RE: **Waiver Approval**  
6965 Mink Hollow Road  
Highland, MD 20777

SITE INSPECTION SHEET

CISSEL FARM SECTION 2  
LOT 13  
PLOT PLAN

LOCATION DIAGRAM

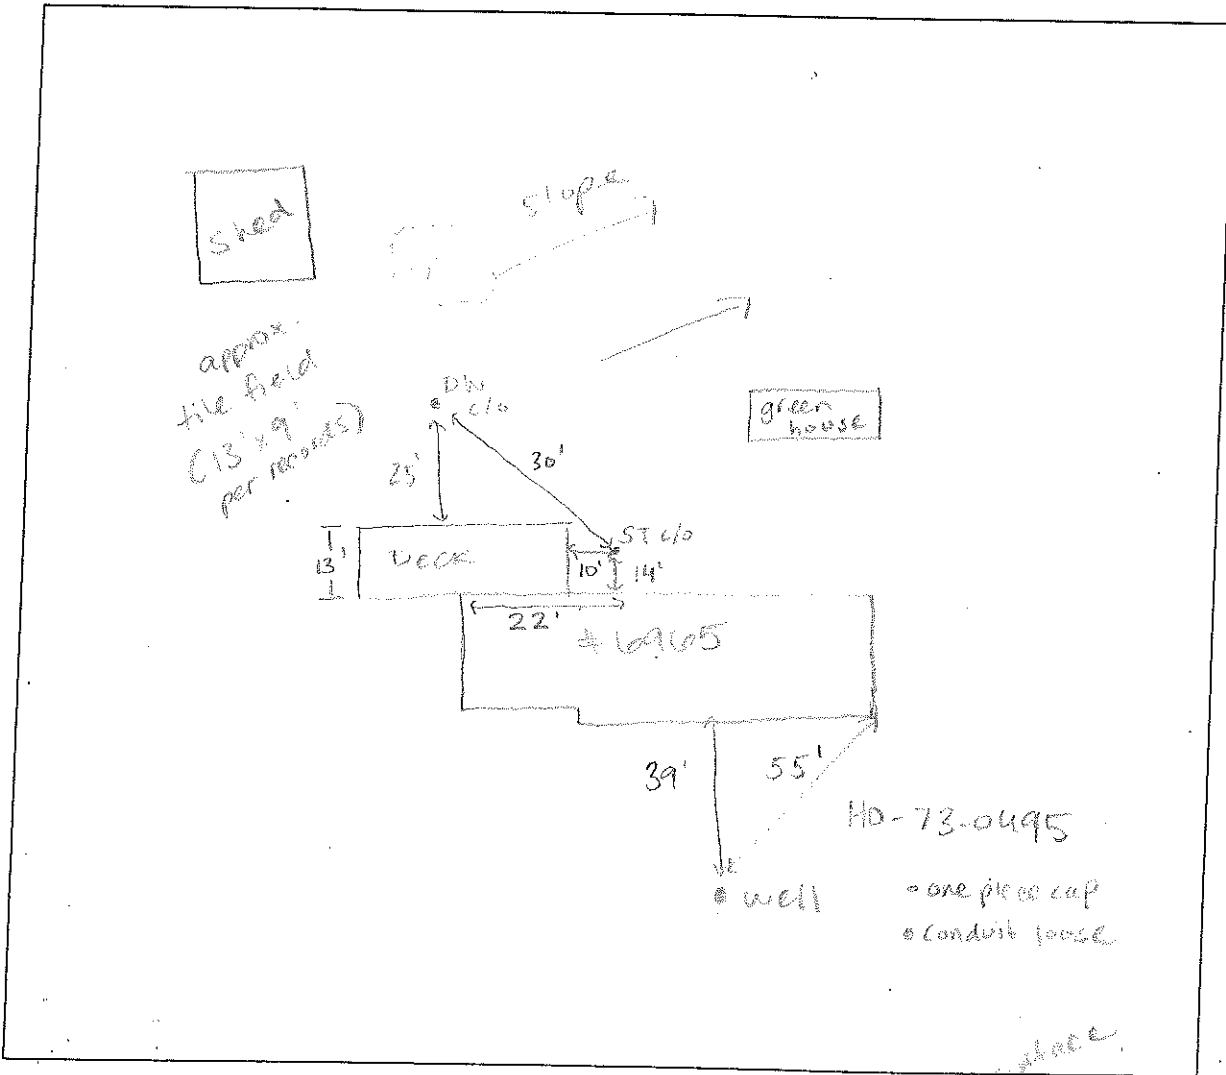
COMMENTS: Liquid level in drywell is ~ 11.5 deep, terra cotta observation pipe to grade on tank and drywell. No signs of surface failure. Recommend securing conduit on well.

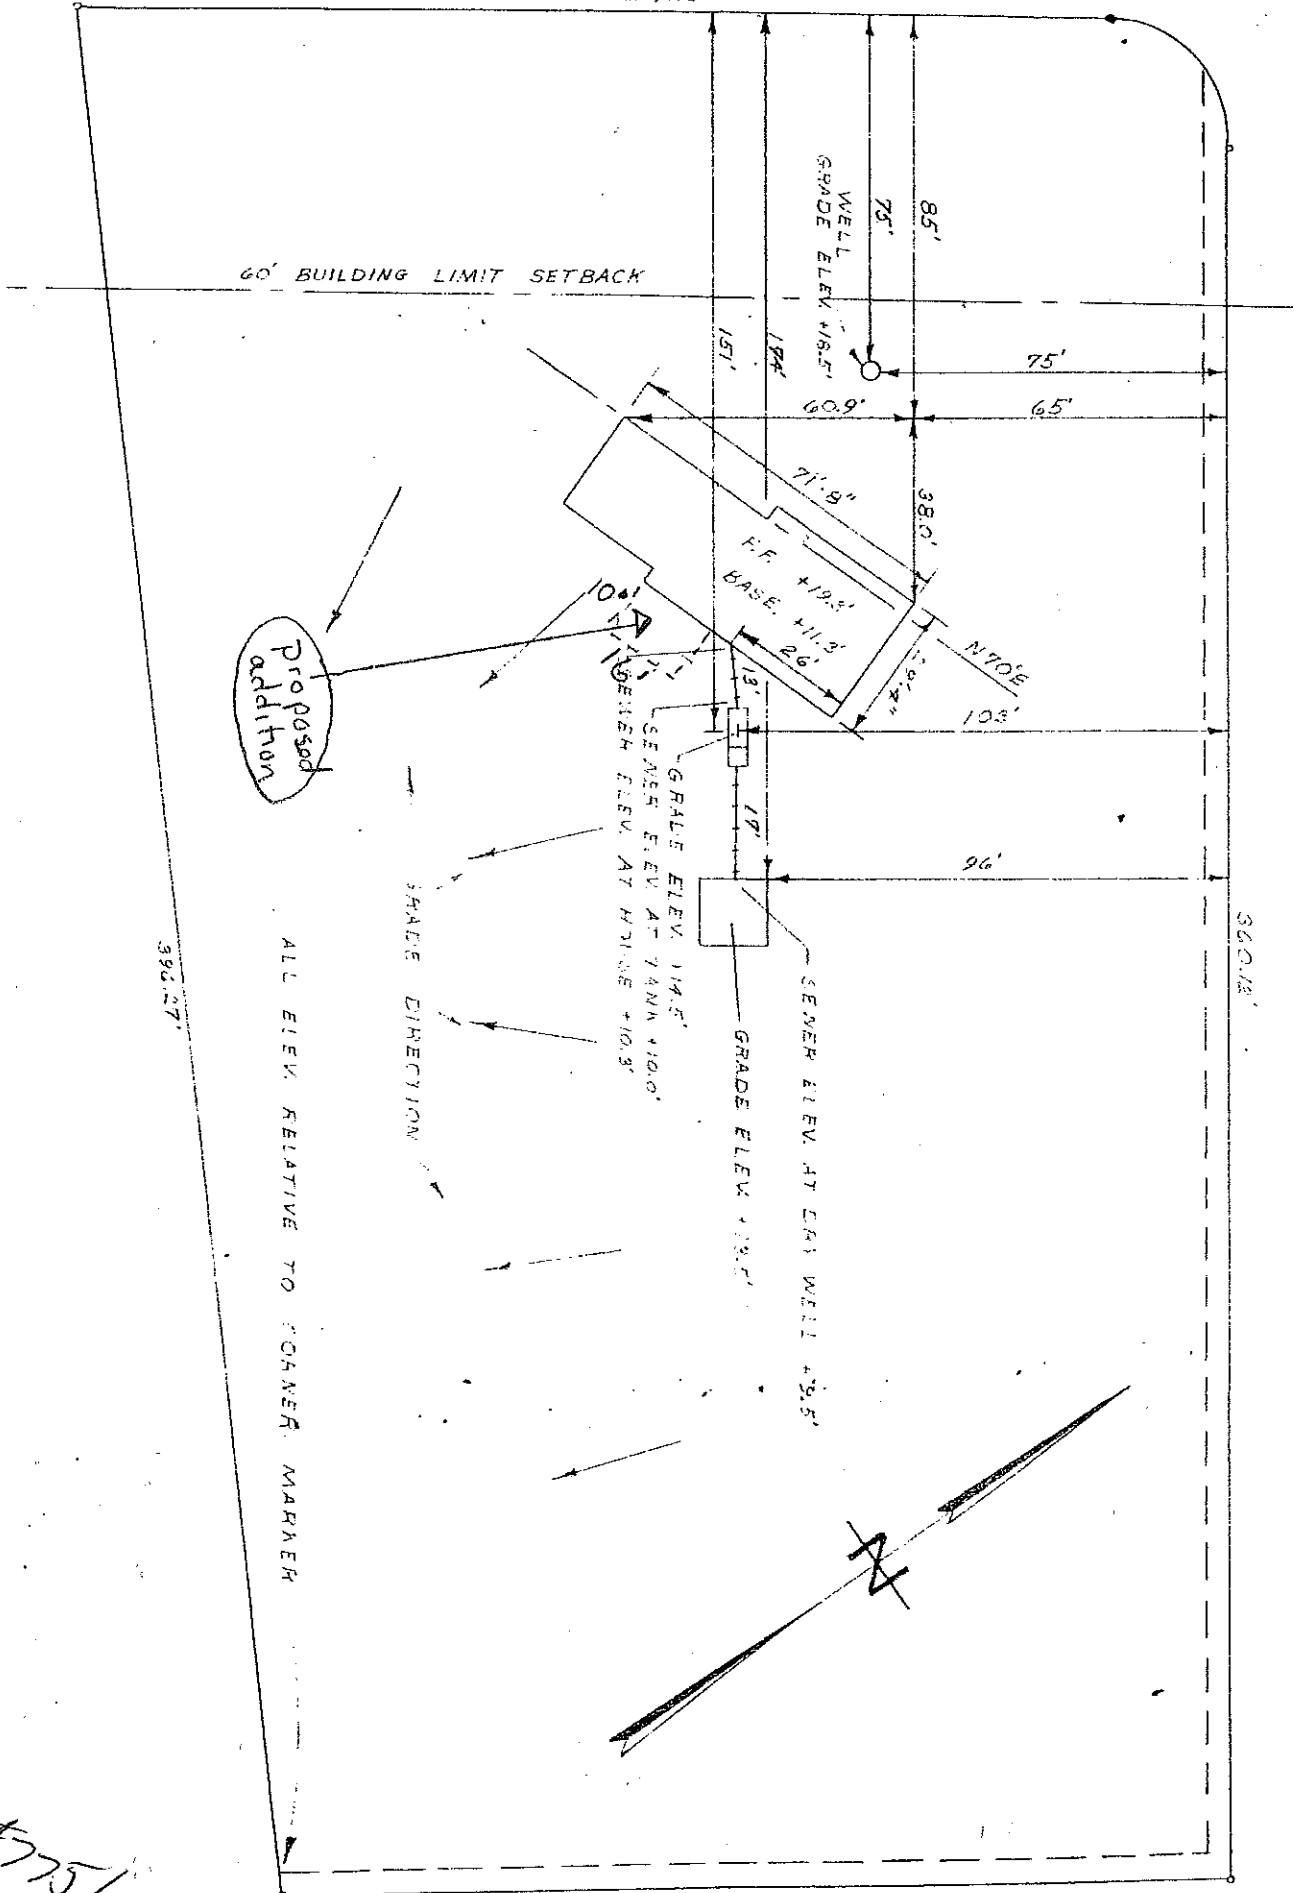
Our plan is to "bump-out" our kitchen by 10 feet. The square footage of this addition will be about 160 square feet. Unfortunately, if we construct our addition as planned, the result will be that the septic tank in its current location will be 10 feet from the "new" foundation. Since we are planning to build a basement foundation for this addition, the proposed addition will not be in compliance with the current setback requirement (septic tank to house with a basement) of 20 feet.

I am including a copy of our plat (see page 3) which will show the existing structure and the location of the proposed addition. The proposed addition is drawn on the plat document in dashed lines and is labeled as "proposed addition". It also identifies the location of the septic tank and drywell. I have also enclosed a copy of the original septic permit and the septic construction plan (pages 4 and 5), which will show the location of the drain field and reserve drain field. To provide additional detail on the addition, I am including a rendering that was prepared by our architect (pages 6 and 7). The first page will show the floor plan and dimensions of the proposed addition, and the second page will provide the elevation view and will provide a sense of the grade.

The Health Department has received your waiver request to allow the existing septic tank to be ten (10) feet from the proposed addition and waive percolation testing to establish a sewage reserve area for future repairs. The waiver has been approved on the basis that the addition does not increase wastewater generation from the home and has little impact on future sewage disposal repair area. Any deviation from the plan submitted with the waiver request will require review by this Department.
